Stannah LIFTS News

Stannah Lifts Newsletter for Site Personnel. Issue 7 November 1999

The New Passenger Lift Safety Gear Tripping Device

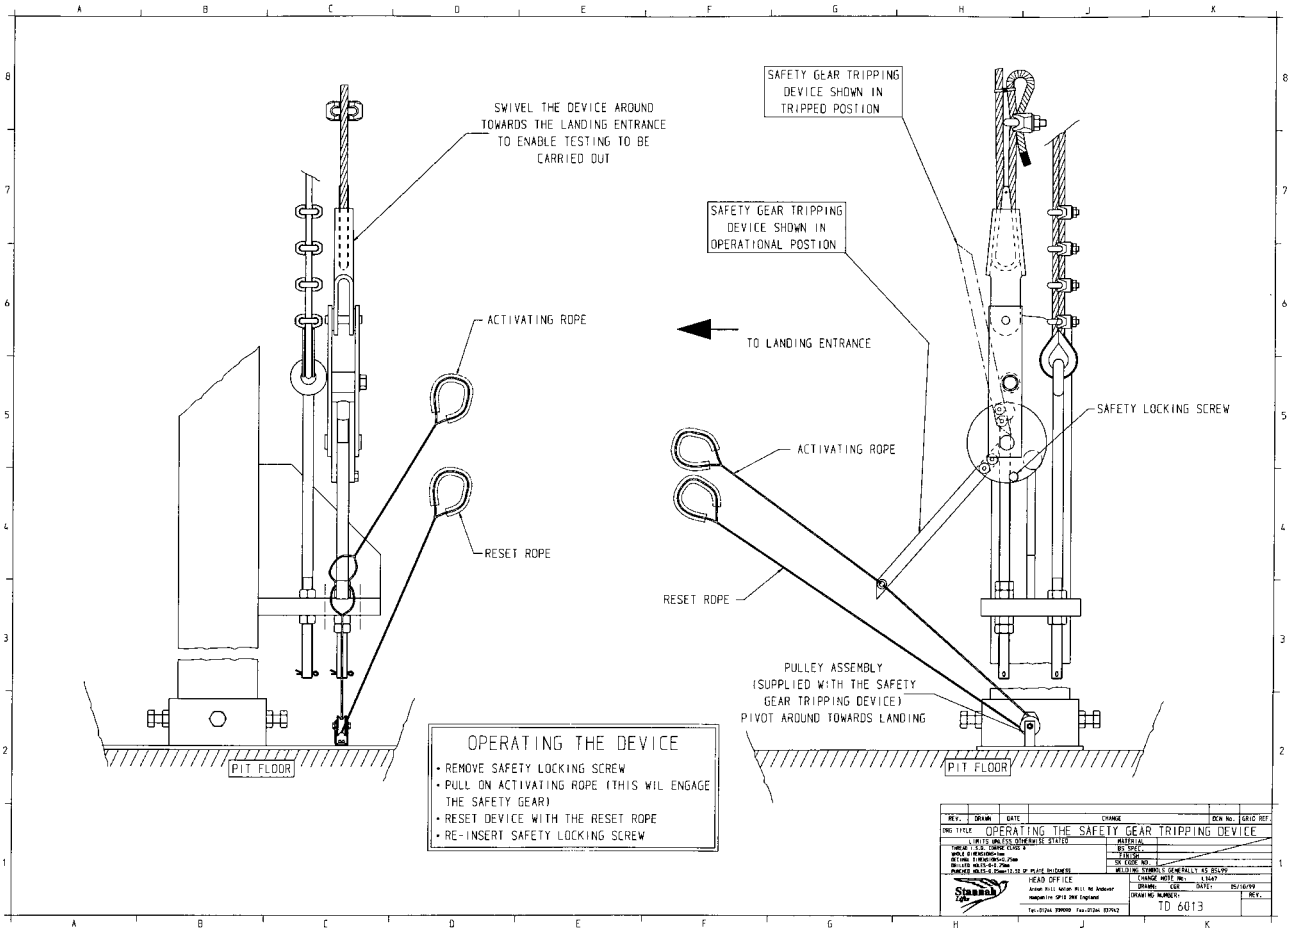
A new safety gear tripping device has been introduced for indirect lifts within the System21 passenger lift range. The mechanism eliminates the requirement for the safety rope which has been removed and should help to improve reliability and ease of installation.

The mechanism is attached to one of the lifting ropes which is terminated in the pit.

It allows testing of the safety gear by inducing a slack rope situation by means of an over centre cam.

Activation of the device is carried out from the landing entrance (with the doors open).
